2 -----  
3 **Comment #55, #56, #57, #63, #70, #104, #105, #106, #107, #117, #120, #121, #122, #126, #128, #326, #327, #399,**  
4 **(TDL #268, #269, #358, #143 from D2.2)**

5  
6 Single-signature DLL state machines:

55 **145.5 Data Link Layer classification**

**Figure 145–43—PSE power control state diagram**

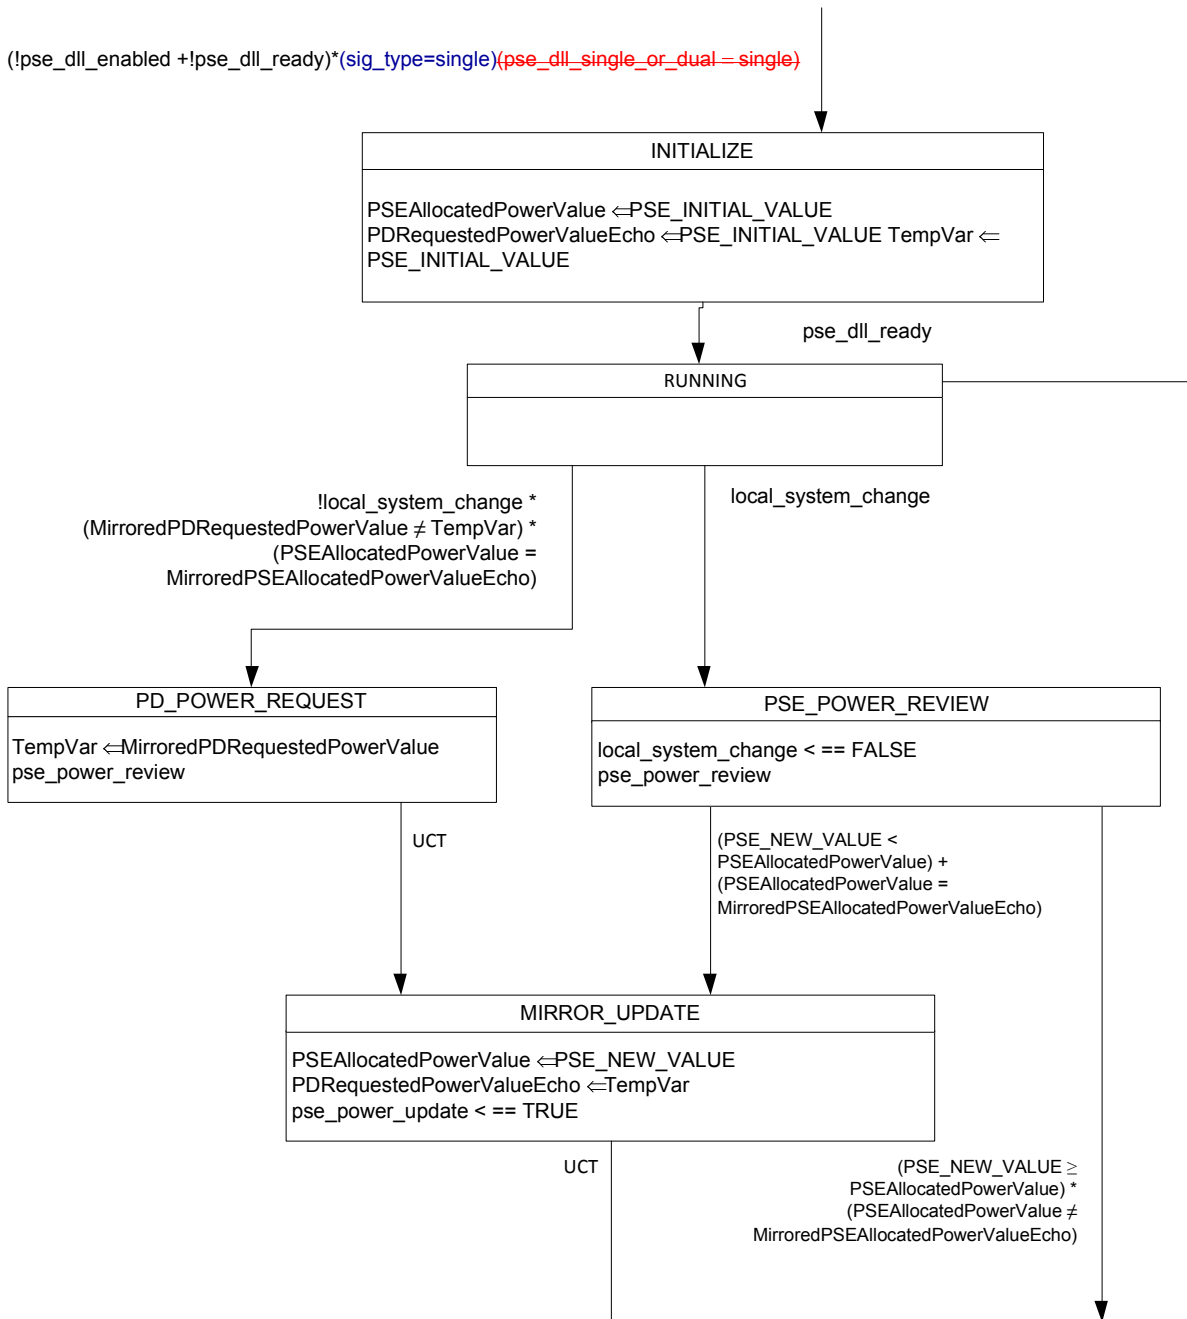
- 7 1. From comment #155 D2.2, the assignment 'pd\_dll\_power\_type <= parameter\_type' in the INITIALIZE state is not required  
8 (Figure 145-44, PD DLL state machine) and was already implemented in D2.3. Removing it also from Table 145-39.

- 9 2. From comment #167 D2.2, the assignment 'pse\_dll\_power\_type <= pse\_power\_type' in the INITIALIZE state is not required  
10 (Figure 145-43, PSE DLL state machine) and was already implemented in D2.3. Removing it also from Table 145-39.

365 **Make the following changes in Figure 145-43:**

Figure 145–44—PD power control state diagram

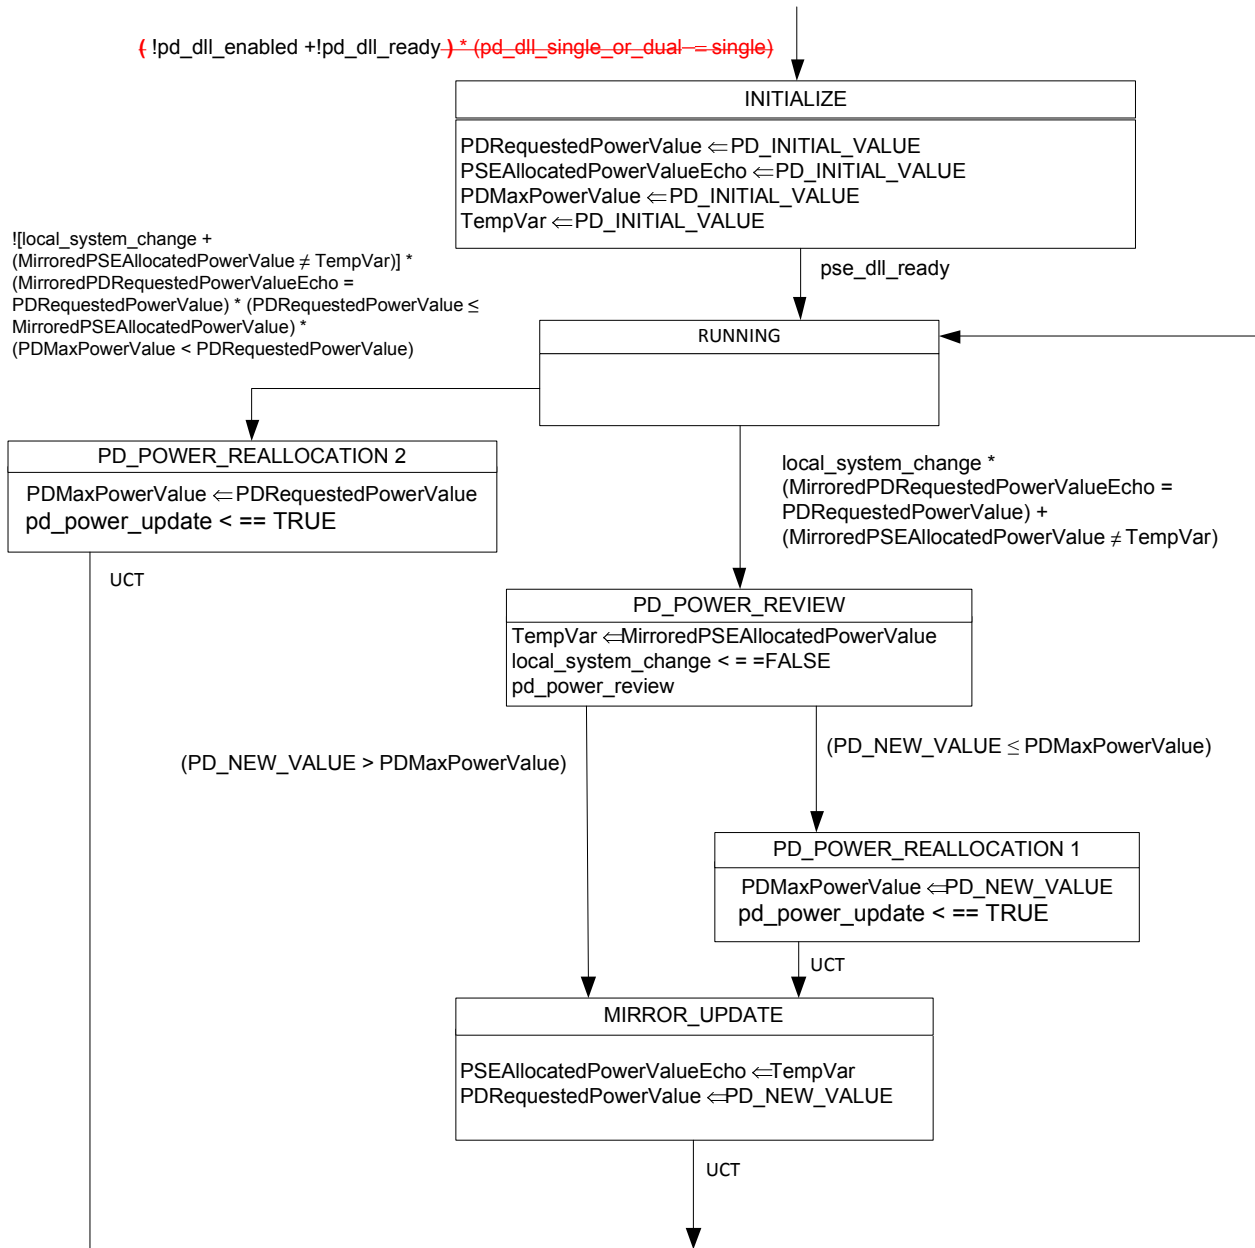
372 Make the following changes in Figure 145-44:

Figure 145-47—PSE power control state diagram Alternative (X) when connected to a dual-signature PD mode (X)

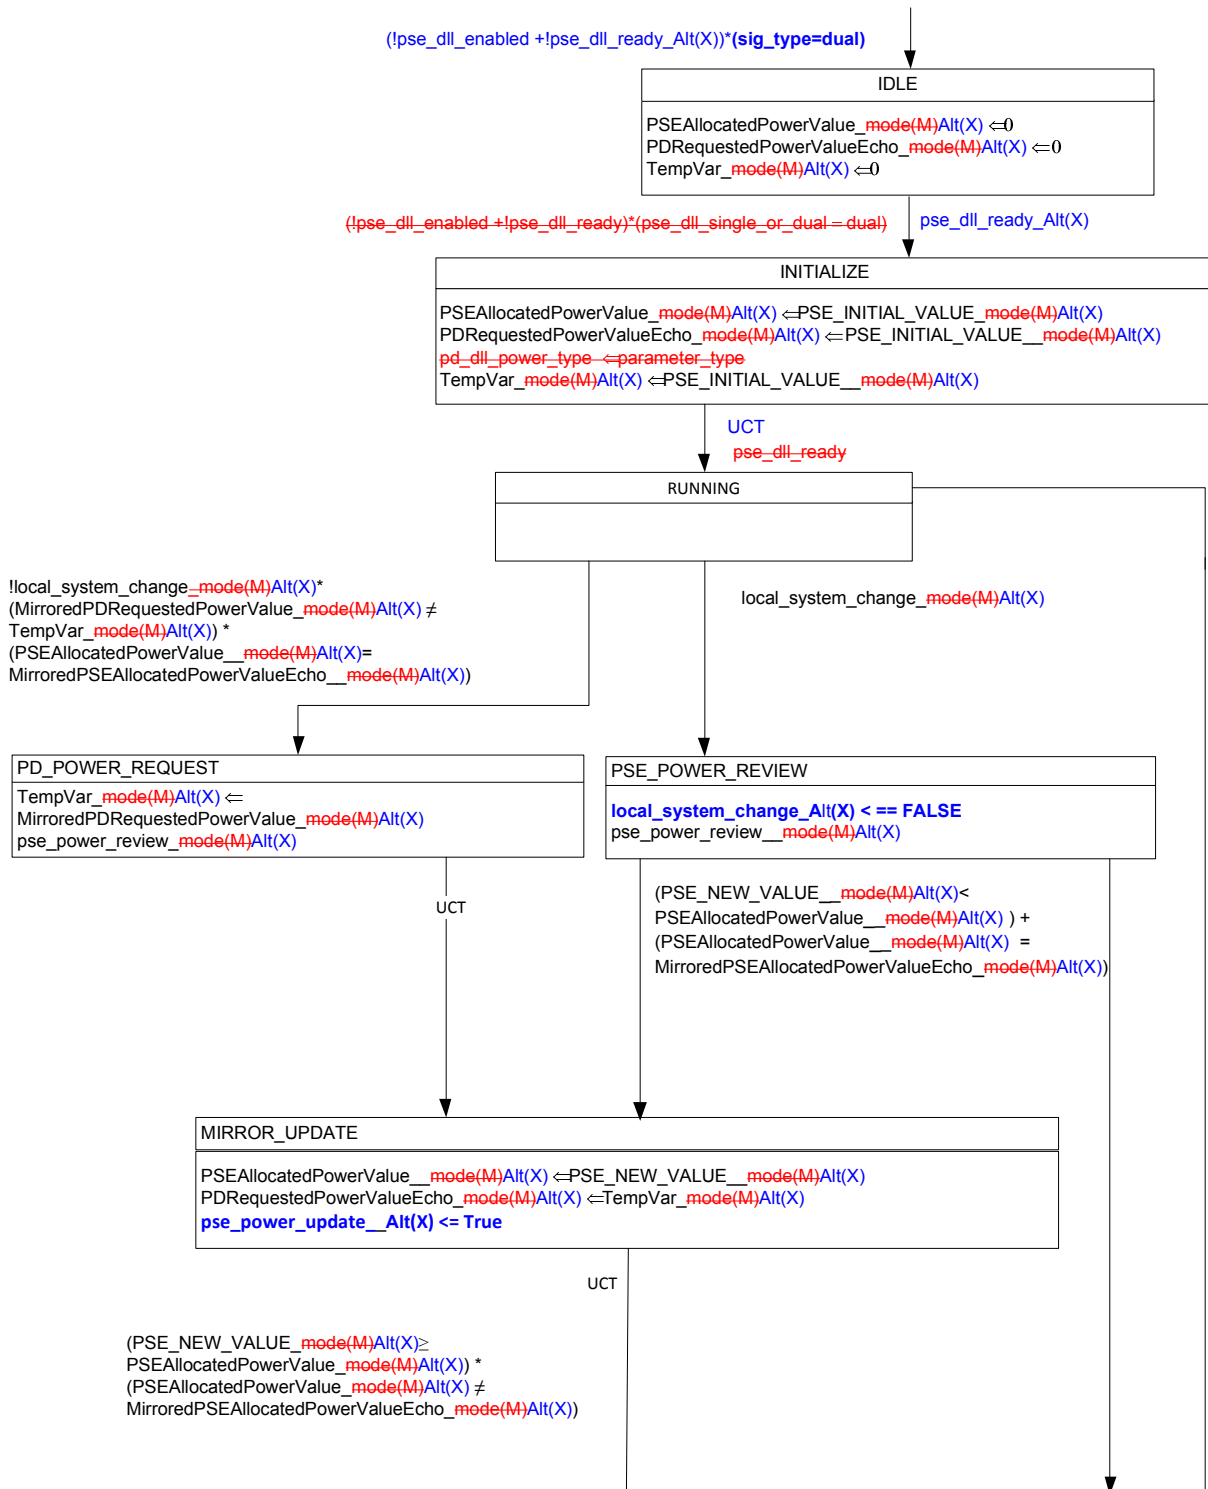
- 29 11. From comment #167 D2.2, the assignment 'pse\_dll\_power\_type <= pse\_power\_type' in the INITIALIZE state is not required  
30 (Figure 145-47, PSE DLL state machine). Removing pse\_dll\_power\_type from the variable list. It is not used by the state  
31 machines Figures 145-47 and Figure 145-48.

725 *Update the following PSE state diagram Figure 145-47 per the following changes. In addition:*  
 726 *-Verify that all variable extensions are with “\_Alt(X)” only.*  
 727 **145.5.3.10 Dual-signature State diagrams**  
 728 The general state change procedure for PSEs is shown in Figure 145-47.

Figure 145–48—Dual-signature PD power control state diagram mode(X)

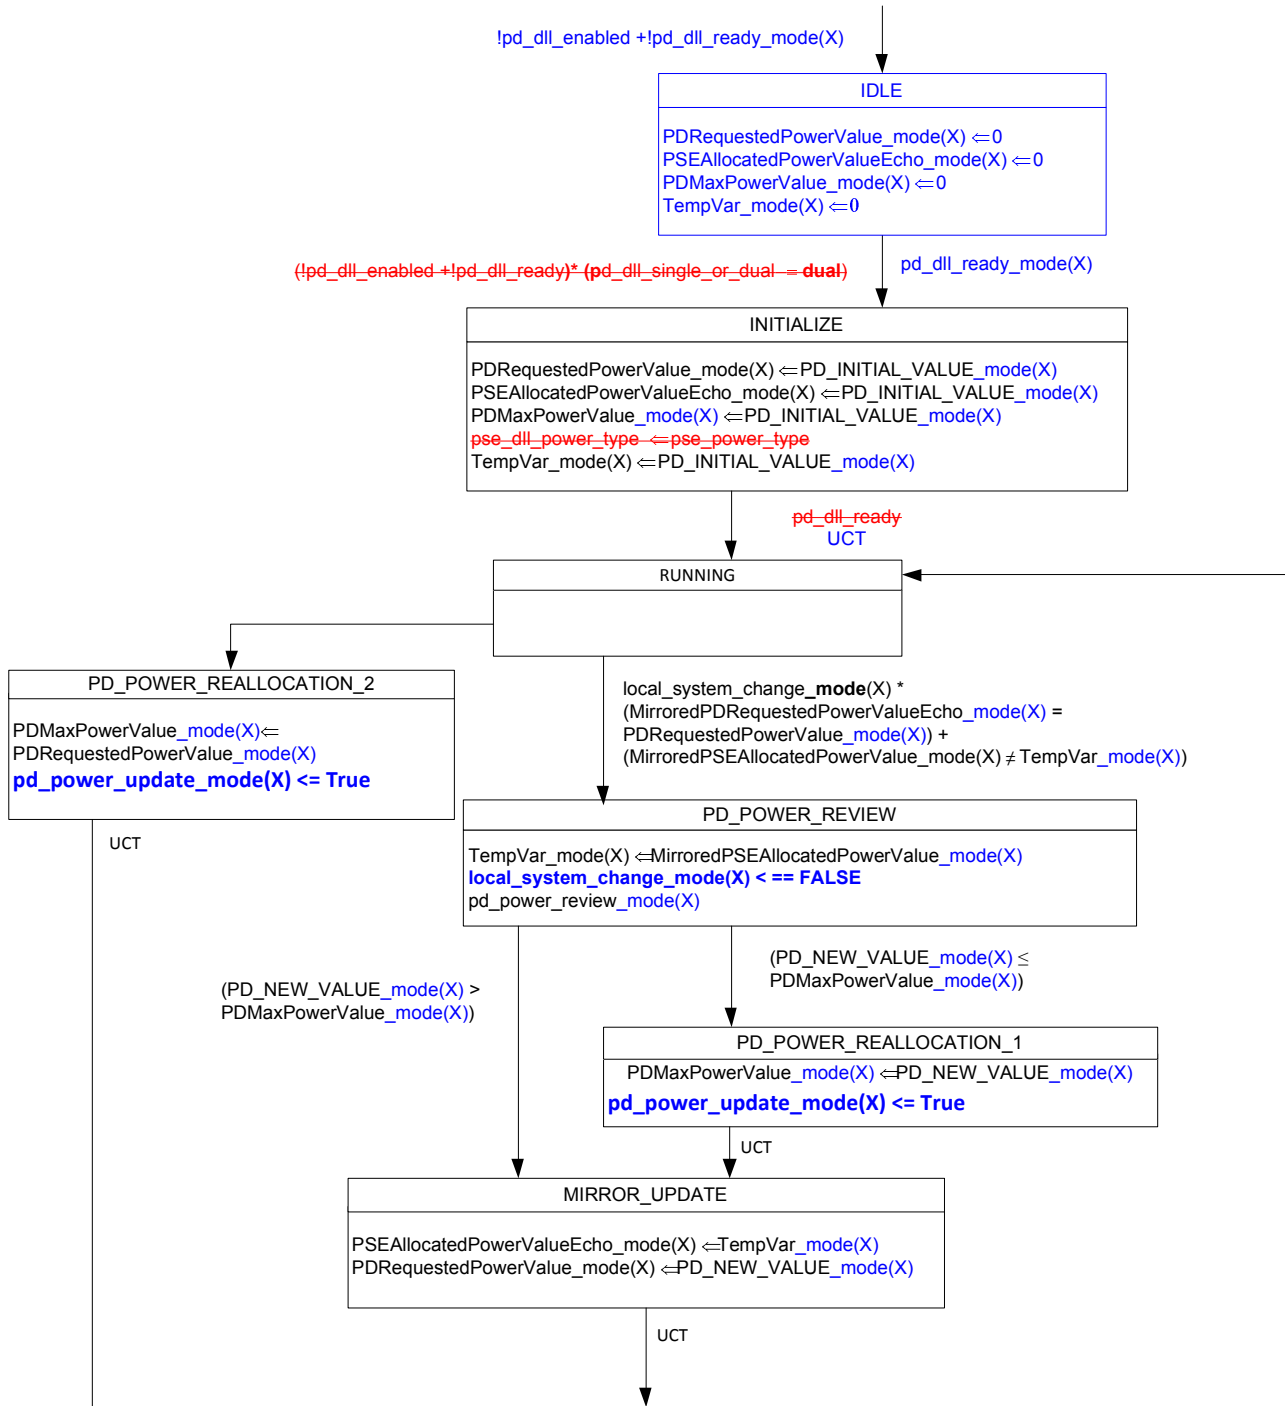
- 32 12. From comment #155 D2.2, the assignment 'pd\_dll\_power\_type <= parameter\_type' in the INITIALIZE state is not required  
33 (Figure 145-48, PD DLL state machine). Removing pse\_power\_type from the variable list. It is not used by the state machines  
34 Figures 145-47 and Figure 145-48.

732 **Update the following PSE state diagram Figure 145-48. In addition:**  
 733 **-Verify that all variable extensions are with “\_mode(X)” only.**  
 734 The general state change procedure for PDs is shown in Figure 145–48.  
 735
